**NEW BUILDING FACILITY:
CBC OFFICE BUILDING**

1
P-1
1st FLOOR PLUMBING PLAN
SCALE: 3/16" = 1'-0"

REV #	DATE	BY	CHECKED	DESCRIPTION
1	3/3/09	TGW		REVISED TO SUIT NEW FLOOR PLAN, RELOCATED FLOOR DRAIN, AND ADDED HUB DRAIN AT THE REQUEST OF THE GENERAL CONTRACTOR (A. KNIGHT). REFER TO EMAIL FROM ARCHITECT (D. RIPPERTON) DATED 2-20-09.

WATER PIPING RISER DIAGRAM
SCALE: N.T.S.

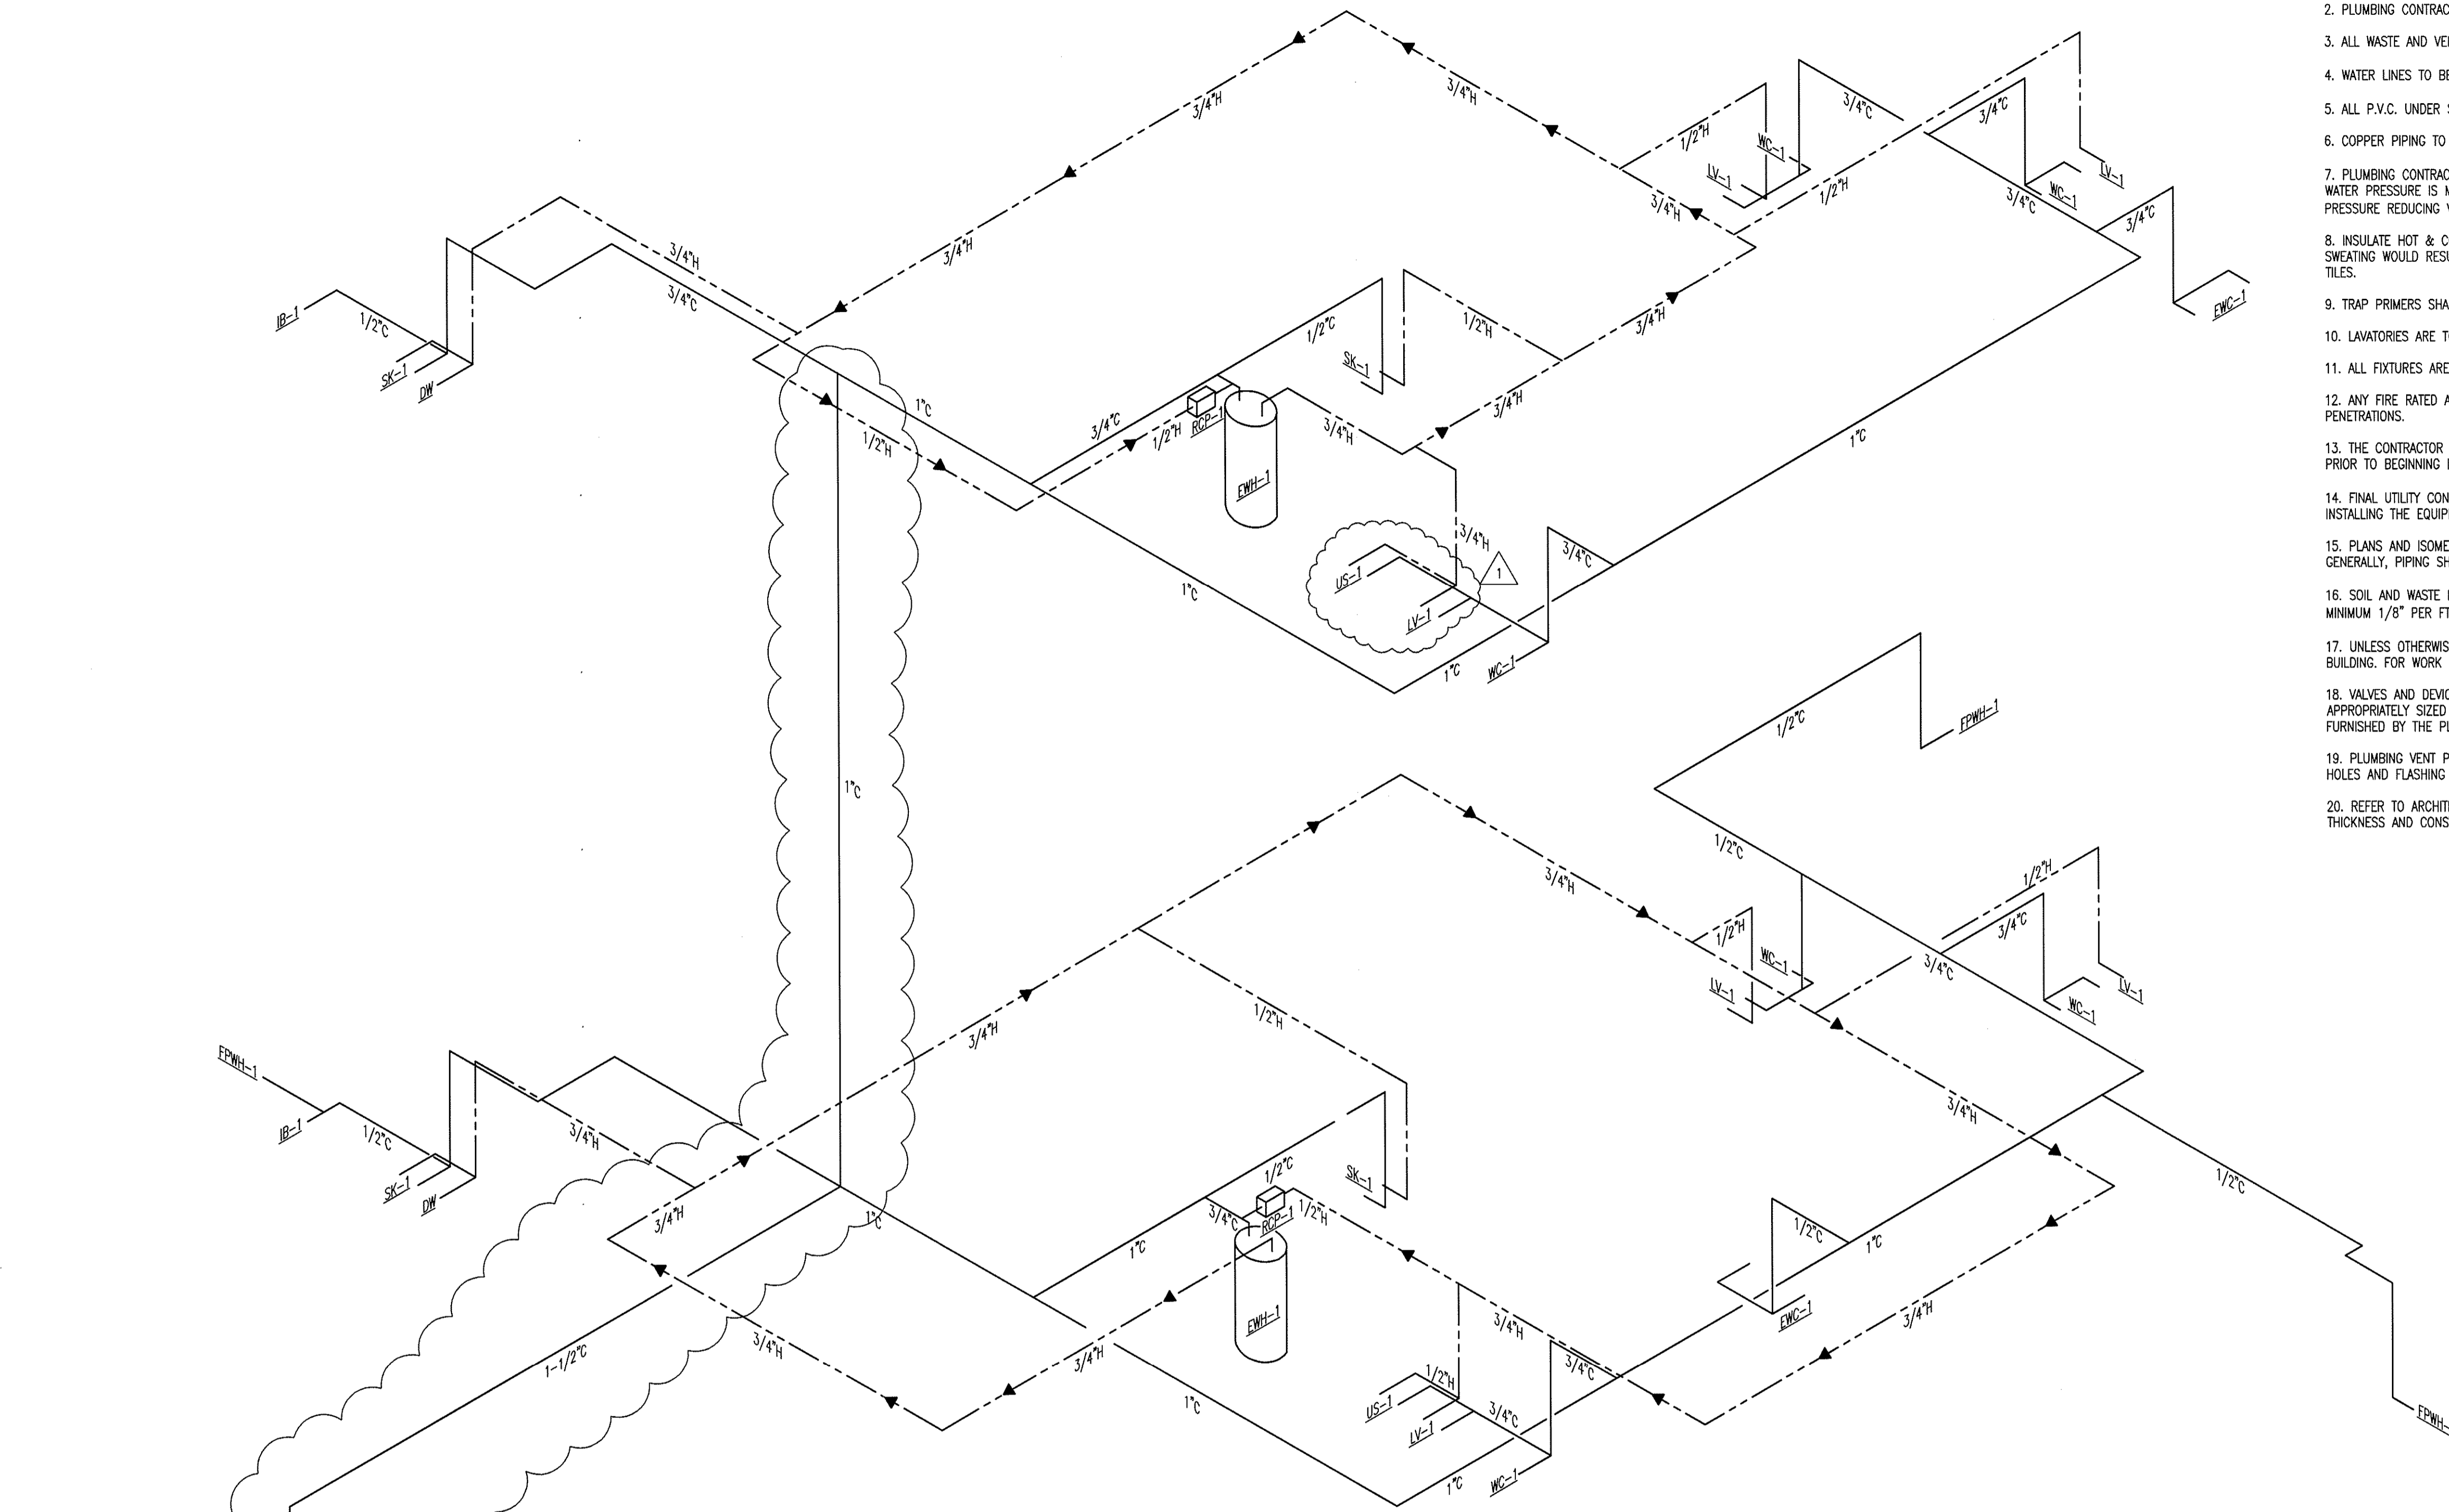
REV #	DATE	BY	CHECKED	DESCRIPTION
1	3/3/09	TGW	JNK	REVISED TO SUIT PLAN VIEW CHANGES, RELOCATED WATER ENTRY LOCATION, AND ADDED UTILITY SINK AT THE REQUEST OF THE GENERAL CONTRACTOR (A. KNIGHT). REFER TO EMAIL FROM ARCHITECT (D. RIPPERTON) DATED 2-20-09.
